DEVELOPMENT REVIEW BOARD
SUPPLEMENTAL SUBMITTAL

PROJECT NO. PR-2018-001579

SI-2021-00304 SITE PLAN, SI-2021-00305 SITE PLAN AMENDMENT
PS-2021-00040 SUMMARY PLAT (PLAT OF EASEMENTS)

RE: PR-2018-001579 – WINROCK TOWN CENTER, SI-2021-00304 SITE PLAN, SI-2021-00305 SITE PLAN AMENDMENT, SUMMARY PLAT (PLAT OF EASEMENTS ONLY)

DATE: 9/29/2021	sheet: SP-1A
SCALE: RE: SCALE	of.

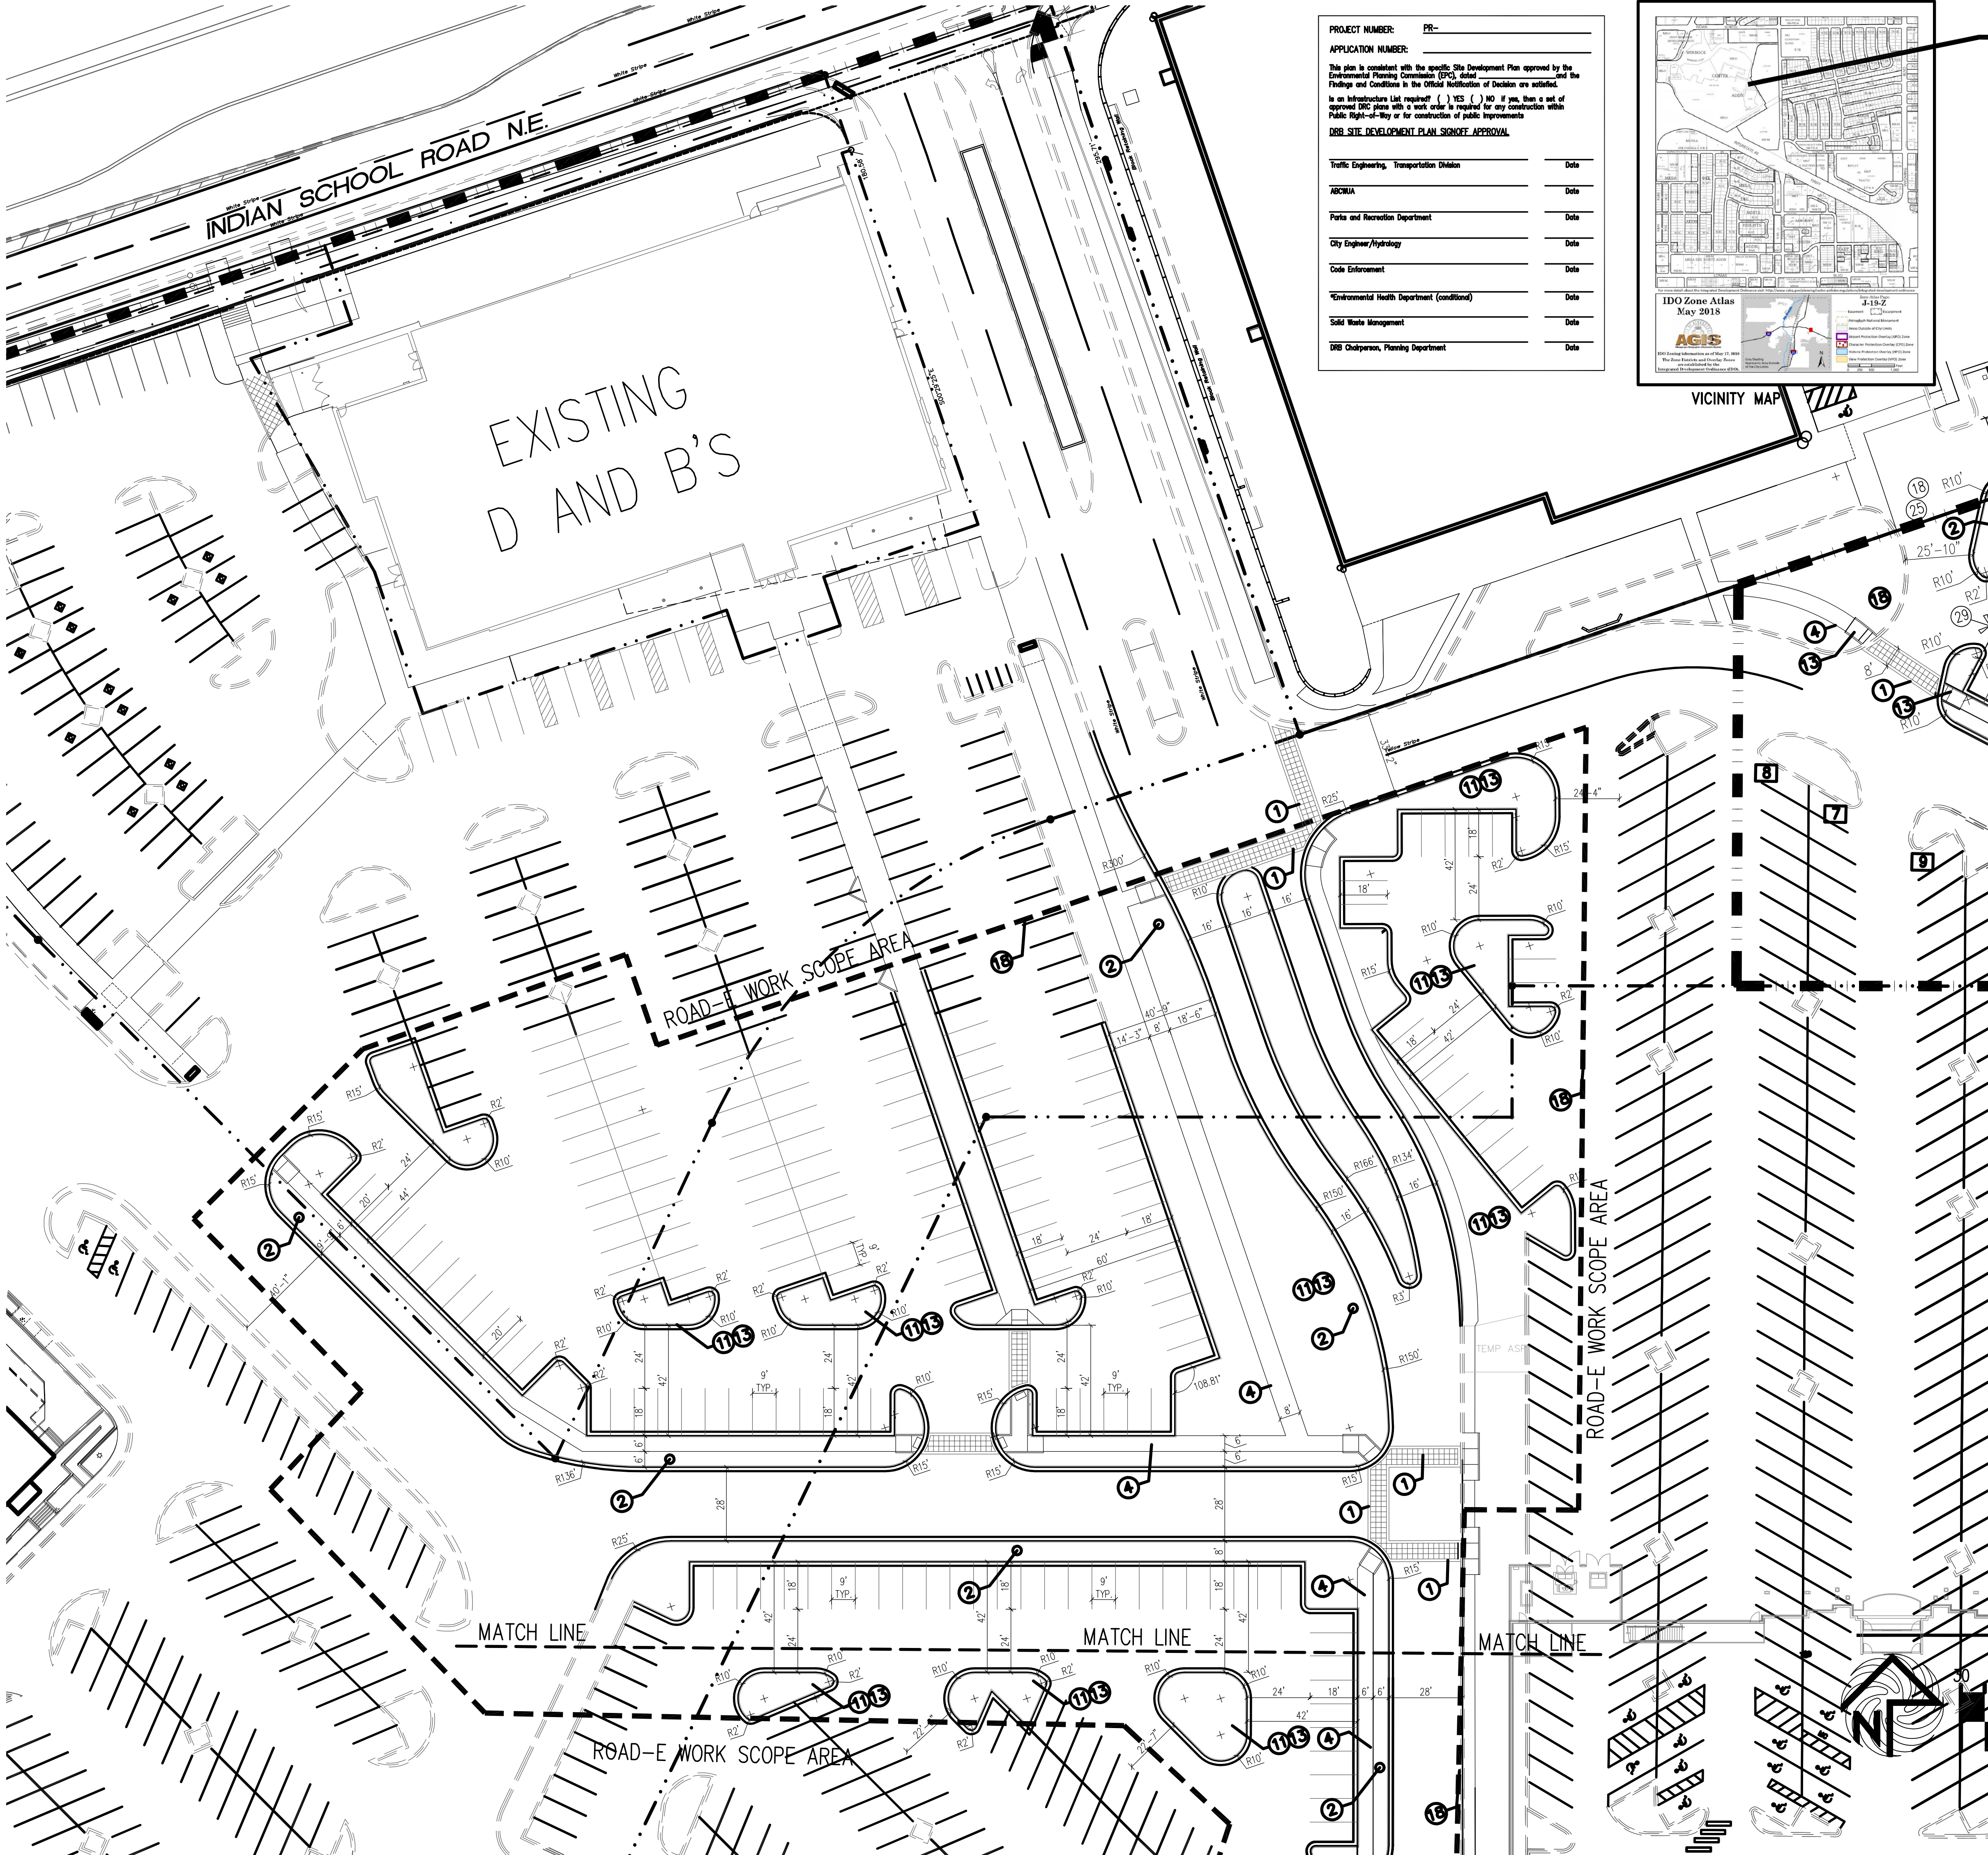
9. Label all new curb ramps on the site plan and reference details. Delete any keyed notes that are not
10. being used regarding the ramps. On the northwest corner, indicate an adequate turning area at the top of the curb ramp and provide dimensions. **Applicant Response: One ramp style is being proposed at three locations, reference details have been included on sheet SP-1A.**

11. Indicate “No Parking” at the back of van accessible aisles. **Applicant Response: Notations have been added on sheet SP-1A**

DATE: 07/29/21
 SCALE: AS NOTED
 SHEET: C200

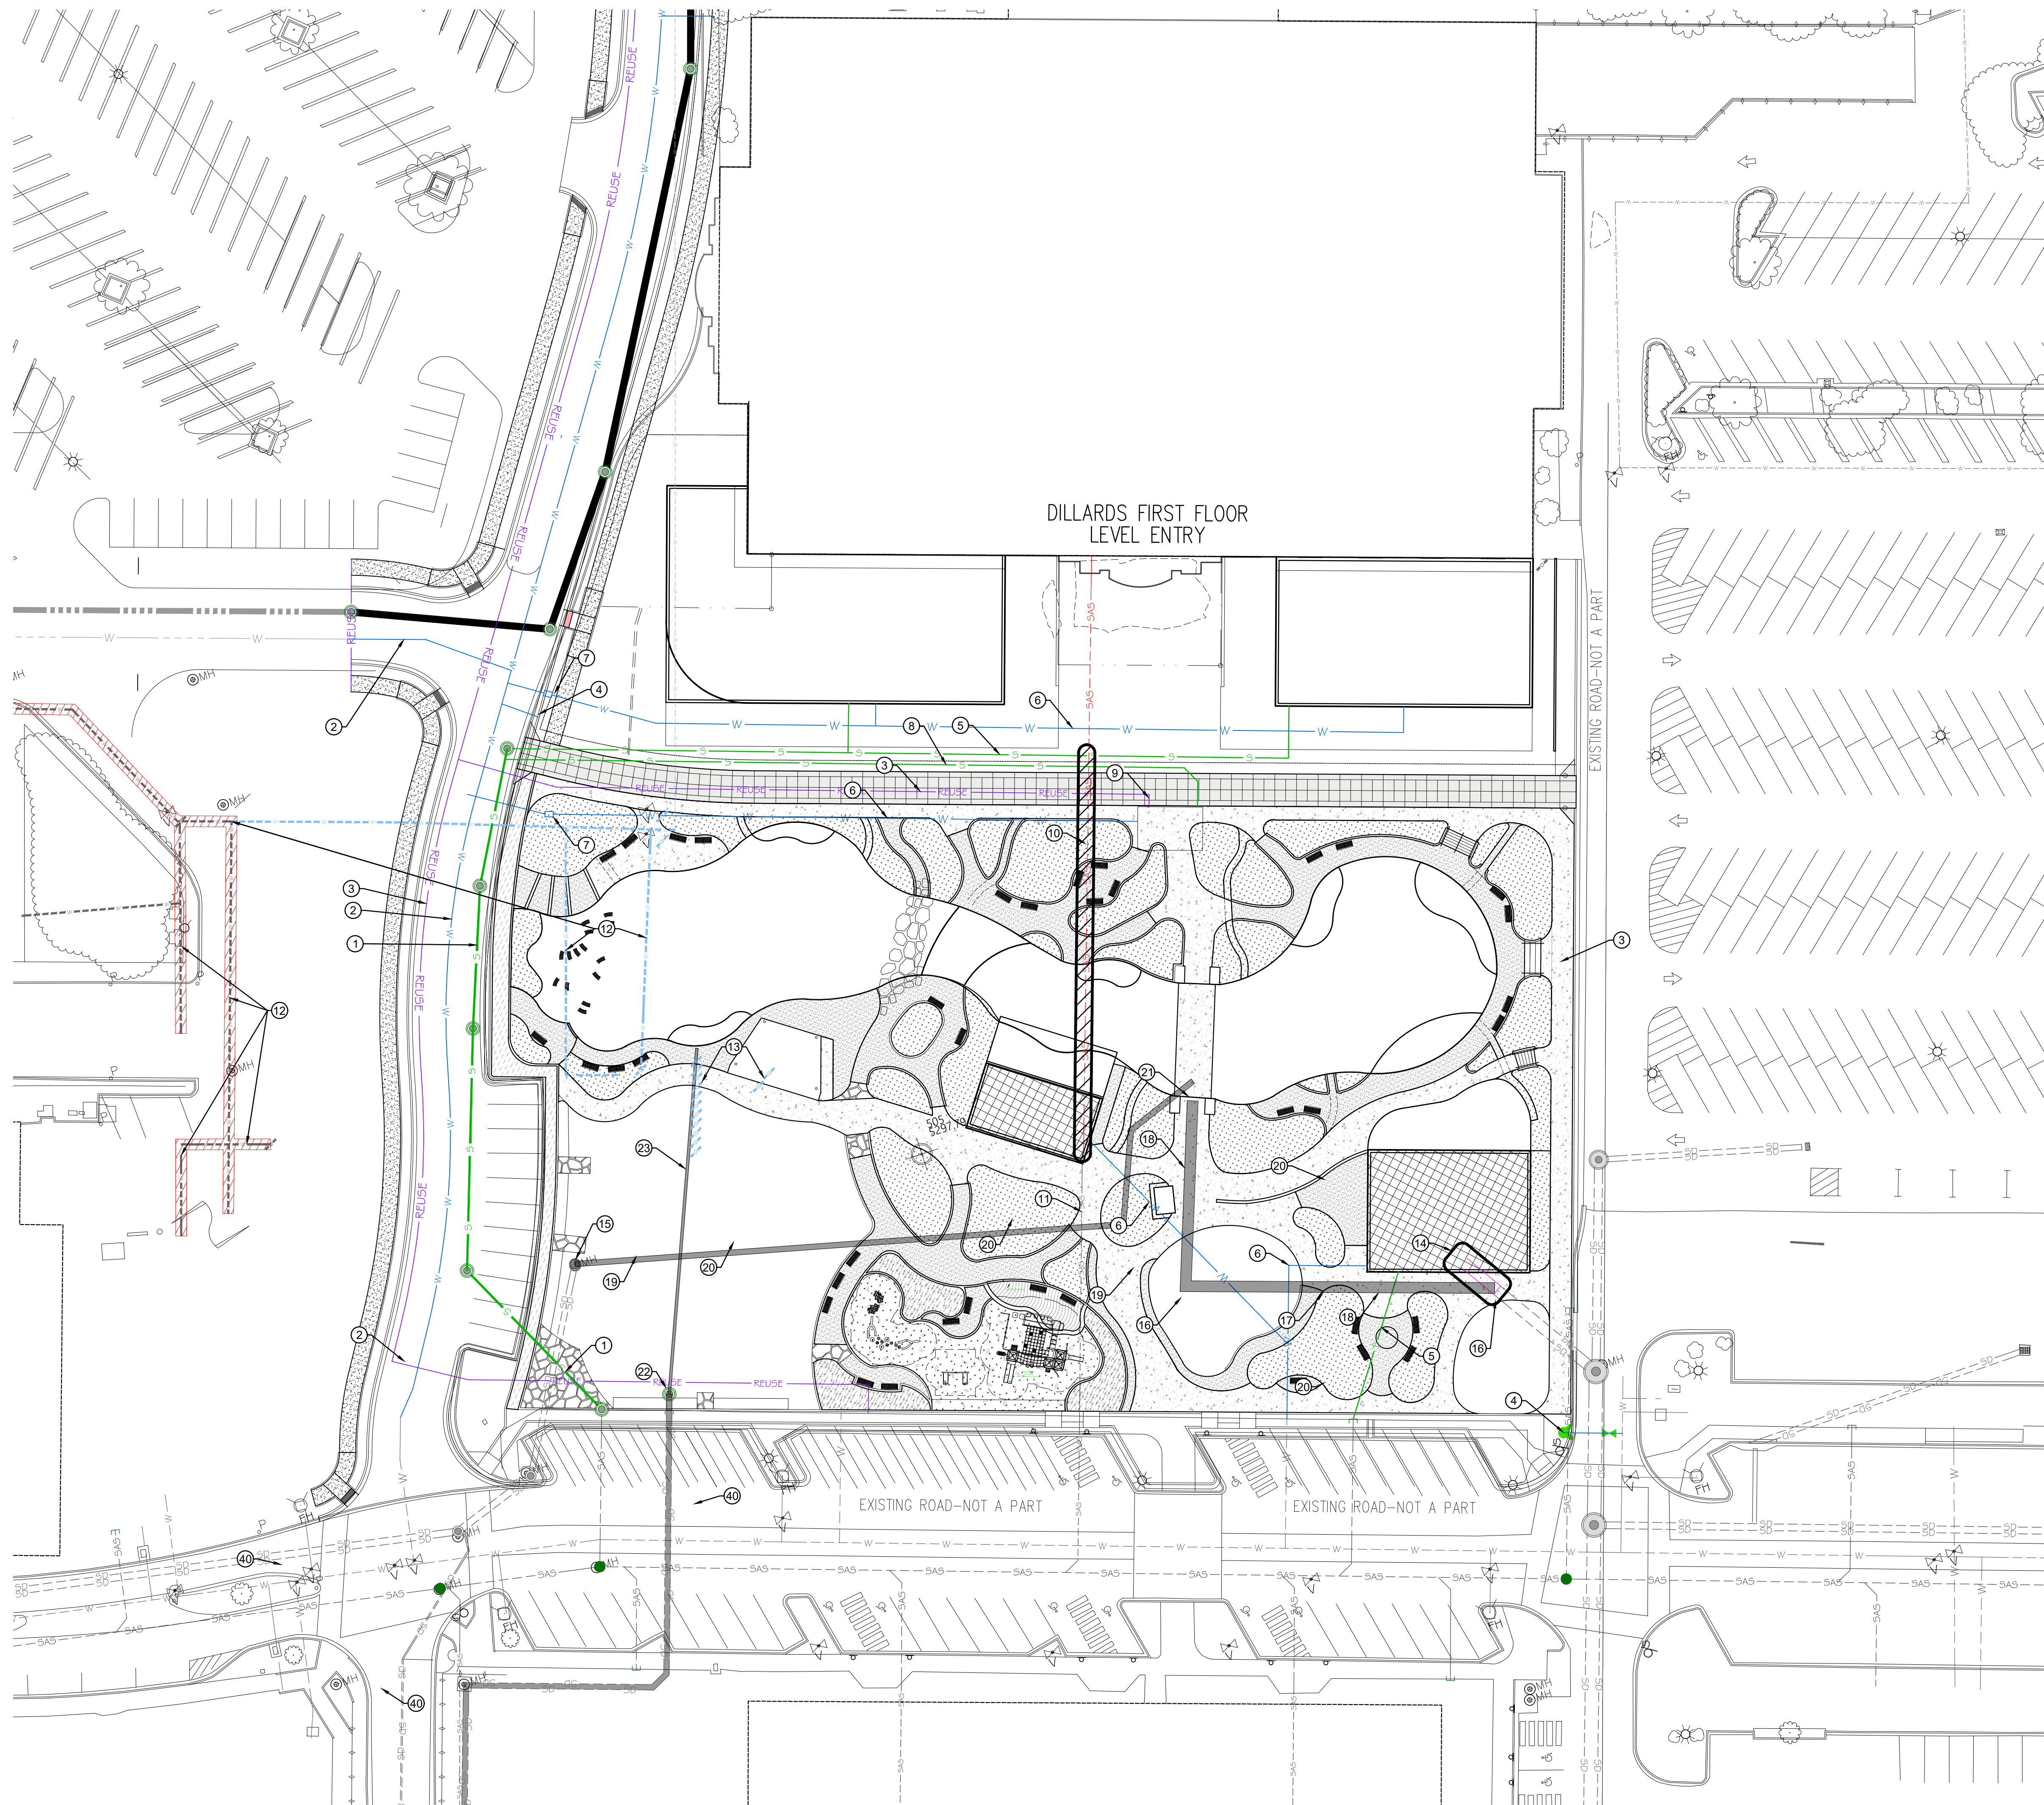
- b. Site Plan
 - i. Please add a master utility plan to provide context for the utility plan for this site.
Applicant Response: Master Utility Plan Included with resubmittal.

- iii. Show the water and sewer easements on the utility plan.
Applicant Response: Public and Sanitary Sewer easements shall be shown and dimensioned on upcoming revised utility plans.

- iv. Please dimension the distance between each type of utility on the utility plan.
Applicant Response: Public and Sanitary Sewer easements shall be shown and dimensioned on upcoming revised utility plans.

- vi. Please correct the callout for "4" on the northeast side which appears to depict an existing line to be removed.
Applicant Response: Updated.
 - vii. Please coordinate with the ABCWUA Utility Development and Project Manager for the WWTP to ensure the proposed use demands and methods of filling the ponds are feasible. **Applicant Response: Project Team has been coordinating with WWTP team.**

- ix. Please be advised that encroachments shall not be constructed over the reuse water line. Please review the alignment of the reuse line. Can this line run due north similar to the water and sewer mains? **Applicant Response: Utilities have been realigned.**
